SUBJECT: MODIFICATION OF HEAT FLUX REQUIREMENTS FOR CSAS

PCFR-MEMO-018

Figure 1: Equilibrium and heat flux simulation for TT 2-04a, which forms the basis for CASE #3 in the CSAS heat flux requirements. This has the strike point the farthest up the CSAS and the highest angle of incidence

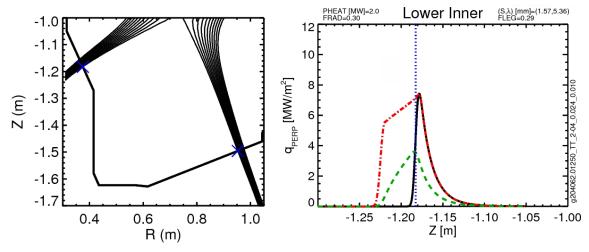
The lower single null L-mode plasmas explored in PFCR-MEMO-008 set the SRD requirements for the CSAS. The two driving are shown in Figure 1 (Case #3) and Figure 2 (Case #1). These represent the highest heat flux and highest angle of incidence, respectively. In addition Case #3 is also the simulation, TT\_2\_04a, corresponding to the largest lower triangularity of the L-mode scan at TRIBOT=0.415 and the strike point with the smallest |Z|. The Case #2 in the SRD for the CSAS (Table 4.5-1) does not correspond to a scenario which should drive or challenge the design. It is a shallow angle of incidence case at low power. If, after adjustment of designs following these new flux requirements, 'fishscaling' is still deemed to be necessary any shallow angle of incidence cases where there may be shadowing be evaluated post-FDR when developing operational guidance for CSAS operation.

The shape of the time averaged profiles shown in Figure 1 and Figure 2 do not well match the 'Extent' feature used to specify spatially localized heat fluxes. In fact they are closer to isosceles triangles instead of right triangles, but these simulations do not reflect empirically realizable scans.

Never-the-less, it is suggested that an extent of 8 cm be used, which for CSAS tiles of poloidal length of 13-14 cm results in a more than a factor of three reduction in energy. This is still conservative, but is expected to eliminate engineering challenges in present designs identified at the PDR. Future detailed modeling post-FDR will be done to help establish operational limits including scenarios that have 'spillover' heat flux from the IBDV which as discussed in PFCR-MEMO-008 "should not drive PFC requirements, they represent a usage scenario for which the compatibility should be evaluated based on delivered CSAS designs". Note that this 'Extent' is assumed to be in the common flux direction, e.g. the heat flux profile extends to smaller |Z|, and should be measured along the surface.

Figure 2: Equilibrium and heat flux simulation for TT 2-05b, which forms the basis for CASE #1 in the CSAS heat flux requirements. This has the highest time averaged heat flux.

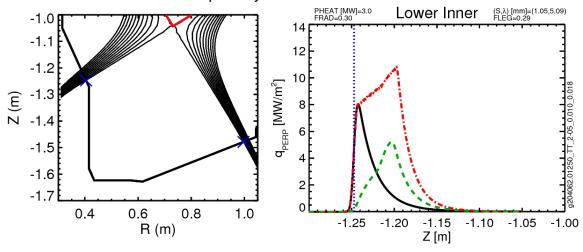
Each CSAS, combining both the Row 5 and Row 6, is estimated to have a surface area of  $0.61~\text{m}^2$ . Thus, for the Case #1, where 0.63~MW of power is directed to the inner target (assuming  $P_{\text{NBI}}=3~\text{MW}$ , 30% radiated, 30% to the inner target), an assumption  $5.2~\text{MW/m}^2$  over the whole surface vastly over estimates the input power. In addition, the Case #3 shown in Figure 2 shows that this power is unlikely to load the region near the top of Row 6 near the CSAS/FW interface. This implies the heat flux requirements for tiles that are limited not by surface temperature but by sub-surface stress states driven by energy input, e.g. 'bowing', are extremely conservative and should be relaxed.
